# SERVICE BULLETIN

ENGINE FUEL AND CONTROL — FUEL DIVERTER AND RETURN VALVE —  
REPLACEMENT OF, TO IMPROVE RELIABILITY

V2500-A1, V2522-A5, V2524-A5, V2527-A5, V2527E-A5, V2527M-A5, V2530-A5,  
V2533-A5, V2525-D5, V2528-D5

# V2500-ENG-73-0240

LOCATION OF THE FDRV FOR V2500-A1 ENGINE MODELS  
73-13-42  
FIGURE 1

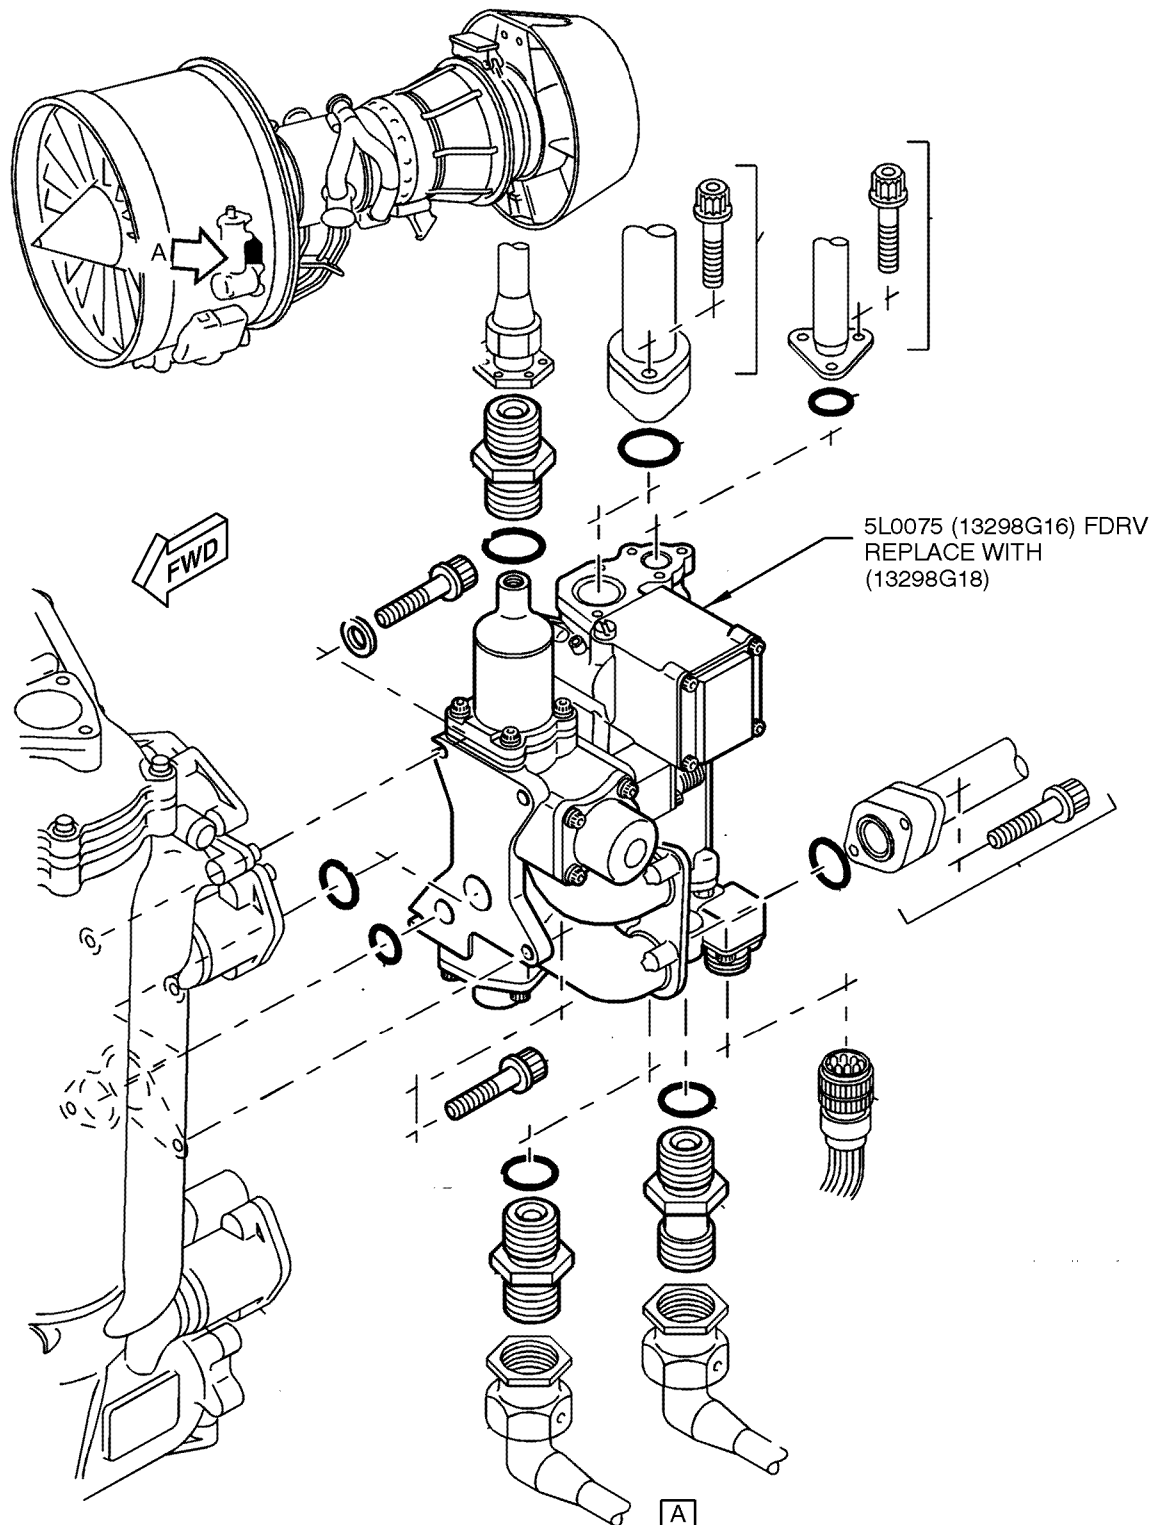
1. Replace the FDRV, PN 5L0075 (13298G16) with 13298G18. See Figure 1.
  - A. Remove FDRV, PN 5L0075 (13298G16) as specified in Reference 5, Aircraft Maintenance Manual, Task 73-13-42-000-010-A.
  - B. Install new FDRV, PN 13298G18 as specified in Reference 5, Aircraft Maintenance Manual, Task 73-13-42-400-010-A.
2. Recording Instructions
  - A. A record of accomplishment is required.
3. Return the removed FDRV to vendor listed in the Vendor Services section for modification to vendor Service Bulletin 13298-73-008 as specified in Reference 8.

1. Replace the FDRV, PN 5L0075 (13298G16) with 13298G18. See Figure 1.
2. Return the removed FDRV to vendor listed in the Vendor Services section for modification to vendor Service Bulletin 13298-73-008 as specified in Reference 8.
3. Recording Instructions
  - A. A record of accomplishment is required.

LOCATION OF THE FDRV FOR V2500-A5 ENGINE MODELS  
73-13-42  
FIGURE 2

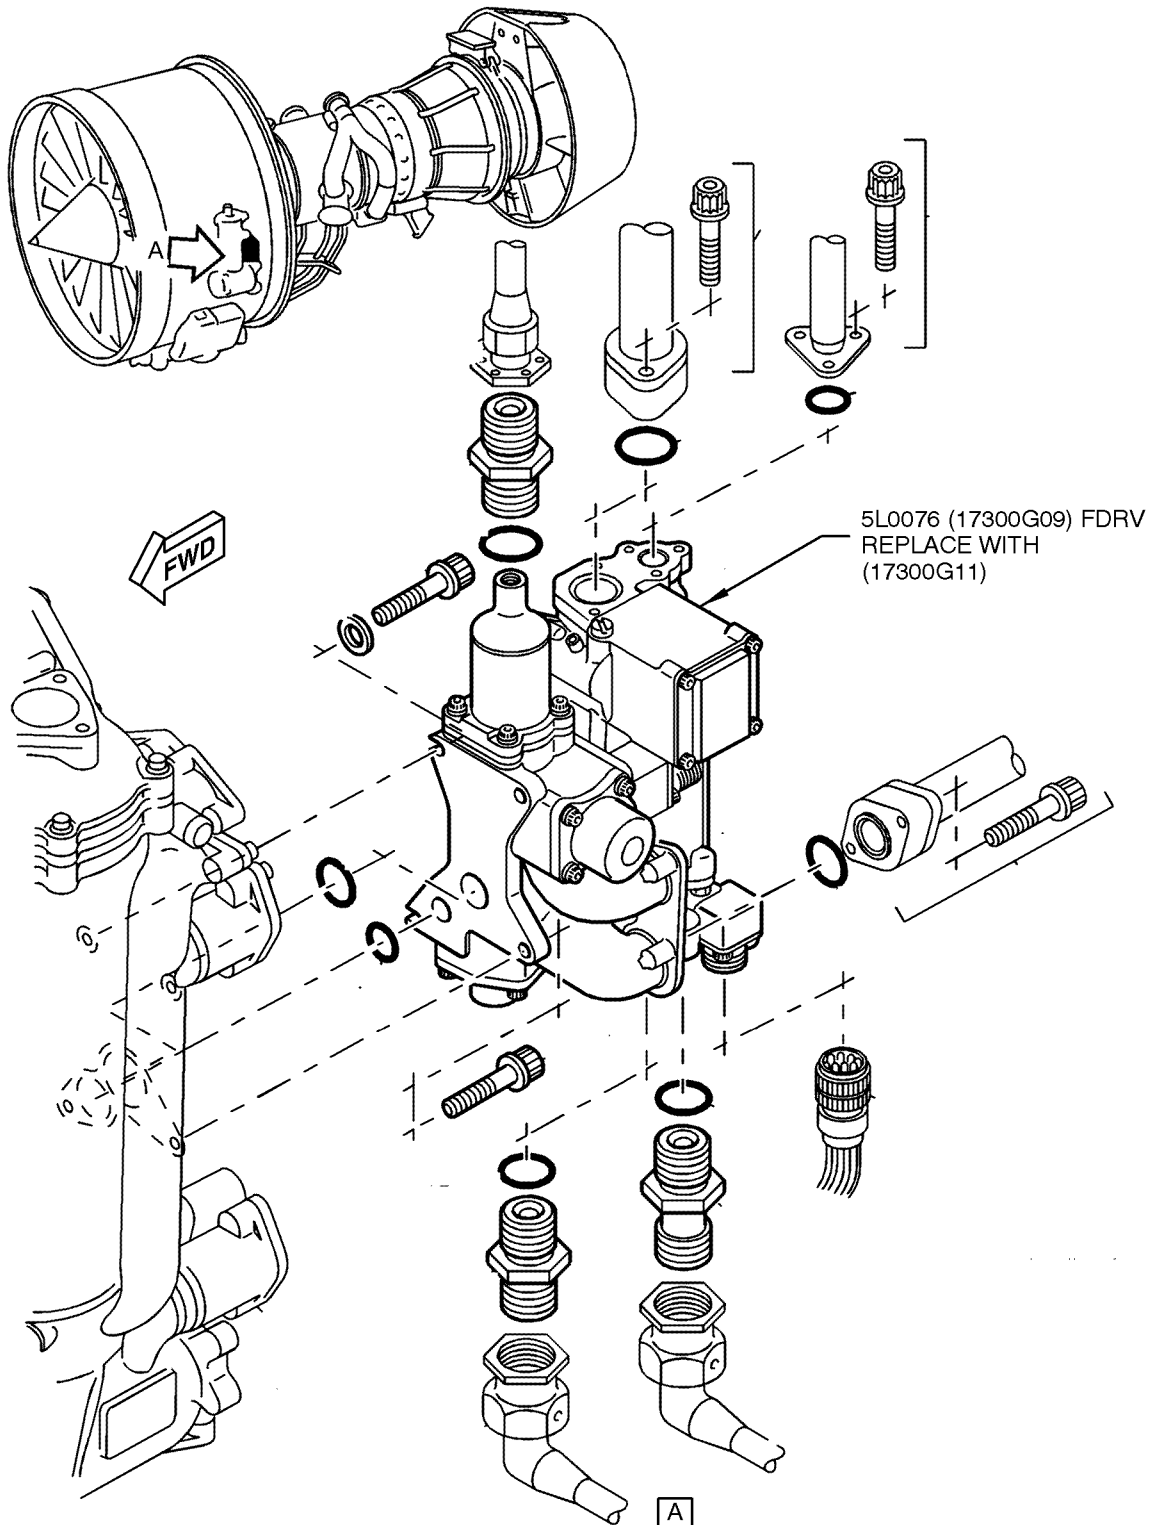
1. Replace the FDRV, PN 5L0076 (17300G09) by the procedure that follows. See Figure 2.
  - A. Remove the FDRV, PN 5L0076 (17300G09) as specified in Reference 5, Aircraft Maintenance Manual, Chapter/Section 73-13-42.
  - B. Install new FDRV, PN 17300G11 as specified in Reference 5, Aircraft Maintenance Manual, Task 73-13-42-400-010-A.
2. Recording Instructions
  - A. A record of accomplishment is required.
3. Return the removed FDRV to vendor listed in the Vendor Services section for modification to vendor Service Bulletin 17300-73-008 as specified in Reference 9.

1. Replace the FDRV, PN 5L0076 (17300G09) with 17300G11. See Figure 2.
2. Return the removed FDRV to vendor listed in the Vendor Services section for modification to vendor Service Bulletin 17300-73-008 as specified in Reference 9.

LOCATION OF THE FDRV FOR V2500-D5 ENGINE MODELS  
73-13-42  
FIGURE 3

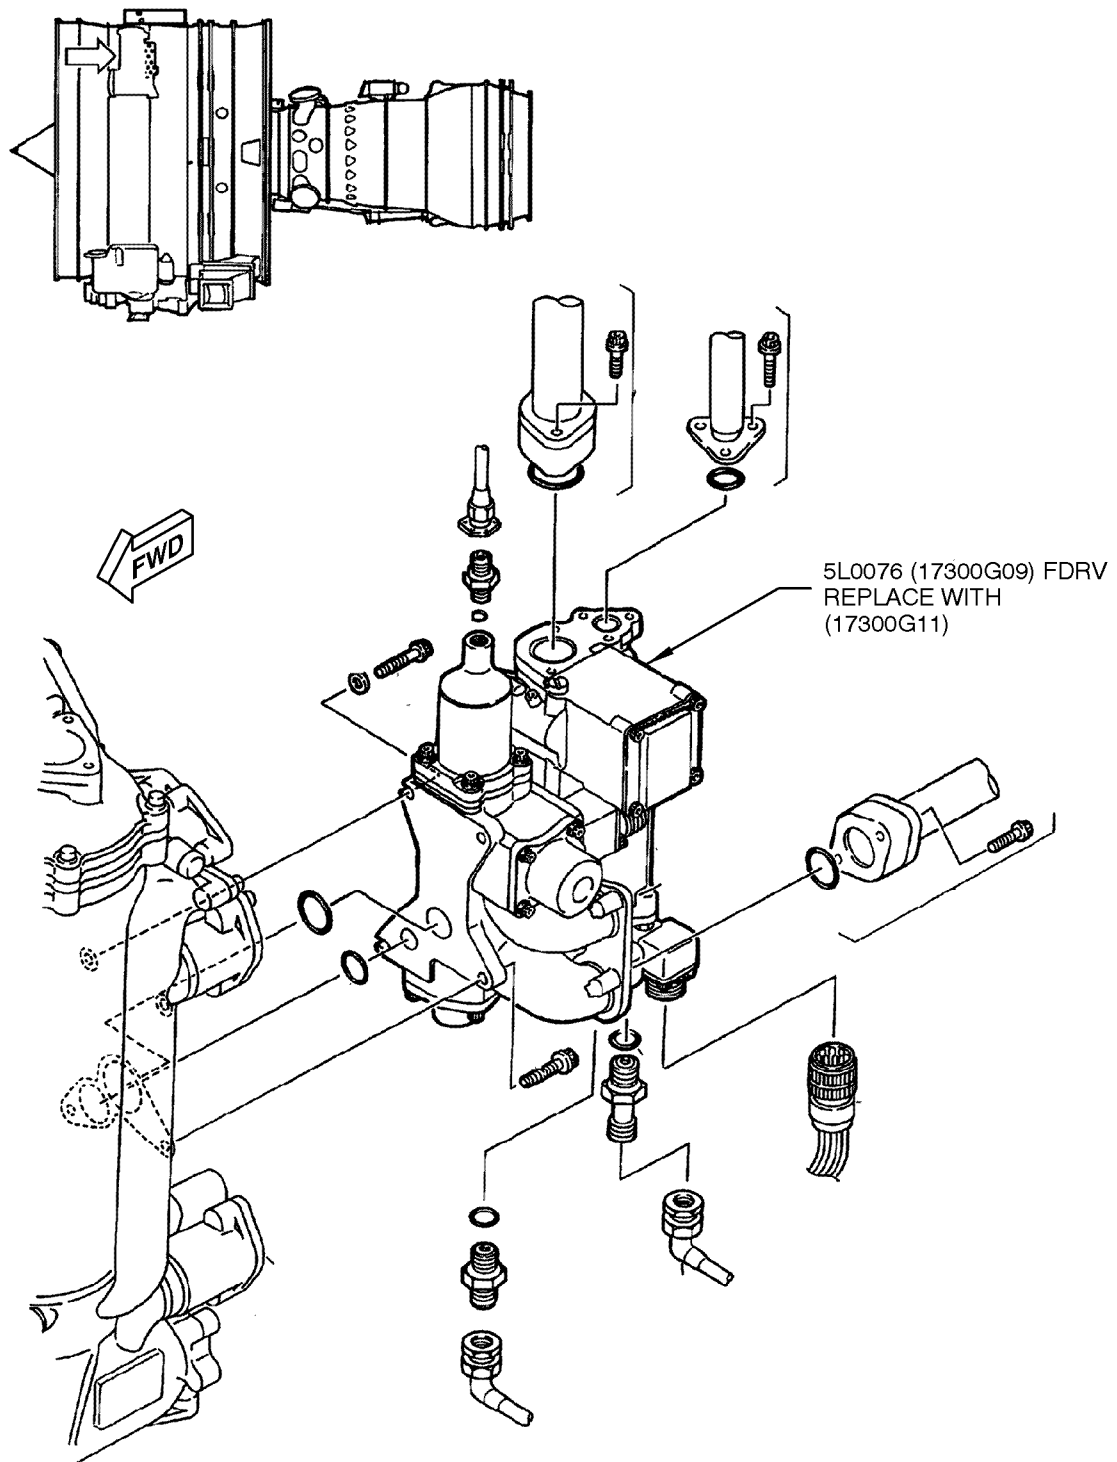
1. Replace the FDRV, PN 5L0076 (17300G09) with 17300G11. See Figure 3.

1. Replace the FDRV, PN 5L0076 (17300G09) with 17300G11. See Figure 3.
